**RCS Add-On: Purpose and Feasibility) of Adding Treatments to RCS Study Design**

Prepared by [The RCS Add-on Work Group](#) Doug Martin, Joe Murray, [John Heimburg](#), [Harry Bell](#), [Mark Meleasom](#), [Patrick Lizon](#)

Date [November 29, 2021](#) [January 3, 2022](#) [March 2, 2022](#)

Figure 1. RCS study design showing site layout and the three harvest sequences (from Figure 1; Volke 2020).

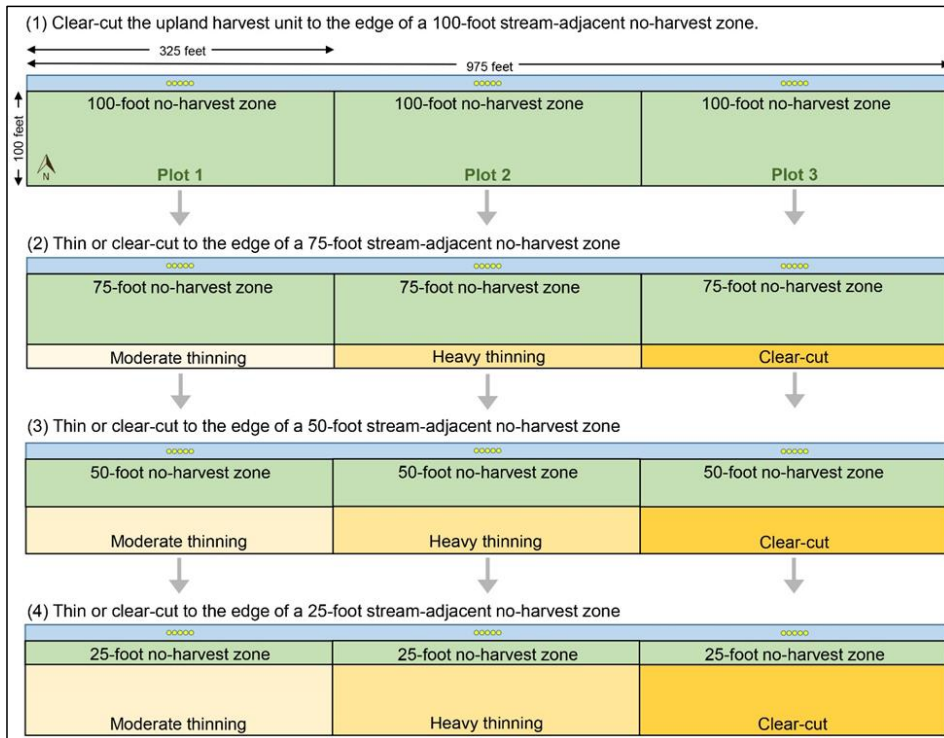
The existing RCS study treatment and plot scheme with Add-On treatments are shown in Figure 1. The Add-On includes the following:

Two additional thinning treatments within Plot 3; one with 75-ft RMZ (Sequence 2b) and one with 50-ft RMZ (Sequence 3b). These Add-On treatments would directly test the WFFA Template Proposal thinning prescription Options No. 1 and No. 3 (Figure 3).

Two additional treatments (Sequence 5) to Plots 1 and 2; (called "additional") extend thinning to stream edge. The addition of these two treatments will increase both the precision and accuracy of the RCS response curve, including the slope and intercept.

The added wider no-cut buffer treatments (i.e. 125, 150, 175, and 200 feet) encompass the full range of buffer widths occurring under current Washington Forest Practices Rules for all stream types. For the sake of consistency with the systematic buffer width treatments in the original study design, we opted to use 25-foot increments for the extended no-cut treatments instead of the irregular intervals associated with RMZ widths. These treatments are proposed in order to validate the assumption, based on extrapolation of limited study data from existing literature, that channel shading is not increased with buffers of any distance beyond 75 to 100 feet. For example, this assumption partially influenced the design of the original RCS plot dimensions and treatments. Adding these no-cut treatments will enable us to explore the shade responses for earlier and later times of the day, earlier and later in the year and among different channel orientations (see figures 4a and 4b of the RCS study design; figure 2 Type N Workgroup Report). The additional no-cut treatments appear to have the greatest potential to affect shading on N-S oriented channels at lower solar altitudes throughout the spring and summer and E-W oriented channels at higher solar altitudes during spring and fall (based on exploratory analysis using the interactive tool on Suncalc.org).
